Comment Table on the Draft Environmental Impact Statement for the Nuclear Power Demonstration Closure Project
Federal and Provincial Technical Review with Quebec Comments – Revision 3

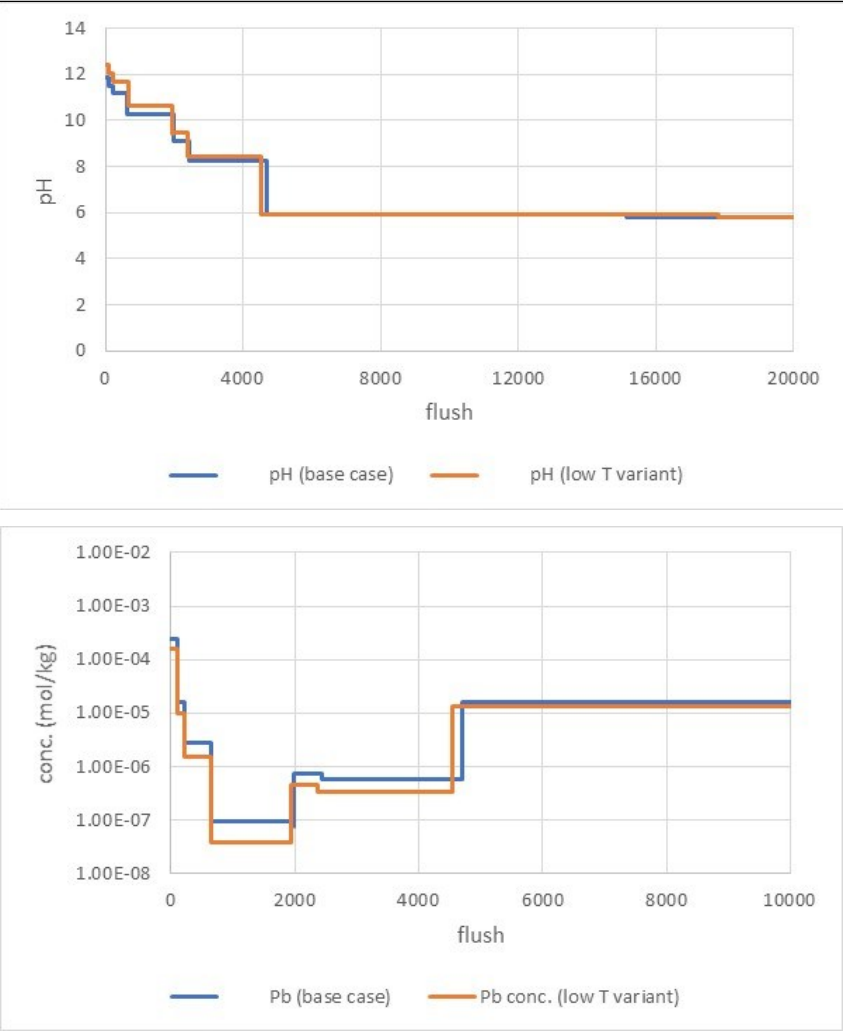
Reference Number	Federal / Provincial Department	Section, Table or Figure	Pg. #	Information Request or Summary of Comment	CNL Response
				through overburden. Groundwater can also flow through bedrock, including the shear zone. In addition, hydraulic conductivity and porosity values from the CRL site are assumed to be the same for bedrock and overburden sands at the NPD site. Hydraulic conductivity and porosity values for the fill material are estimated based on published ranges. Considering the importance of the groundwater model as it relates to groundwater flows into and out of the monolith, and for contaminant movement down-gradient of the monolith, a robust data set for hydrogeological parameters is needed to support the groundwater model. This data should be collected on-site, and should include samples at the shear zone. Page 6 of the Resaturation Modeling Report states: “The tighter hydraulic conductivity in the shallow bedrock relative to the deep bedrock is unexplained.” This rationale does not provide a sufficient level of certainty or site-specific detail required to support subsequent modeling and predictions about long-term performance and risks of the proposed project. Hydraulic conductivities need to be explained in detail for the project site in order to provide a valid basis for the various modeling exercises that are critical to understand the long term performance of the monolith, potential risks, and proposed mitigation. Expectation to Address Comment: Please update the baseline data to include: all borehole logs, a description of tests performed to calculate K-values, all hydraulic conductivity data, and the geometric mean K for each hydrogeologic unit. Provide more accurate hydraulic conductivity values for the overburden, especially for sand units, for example by conducting a more detailed campaign of drilling and testing the overburden. Consider excluding the 1988 K-values from the model dataset unless it can be demonstrated that the measured K-values are valid. In addition, please complete further site assessments to confirm in detail the location of the shear zone. Conduct further hydrogeological investigation of the entire site, including the shear zone, and collect representative data. Summarize this investigation in the EIS along with a rationale for the investigative approach used and any limitations, assumptions or inferences. Update the EIS to describe the assessments completed and provide a more detailed description of the shear zone including location and hydrogeological behaviour. Re-run the normal evolution, disruptive and sensitivity scenarios of the groundwater model to reflect the presence of the shear zone and the hydrogeological data collected. Update and re-run any other models that rely on
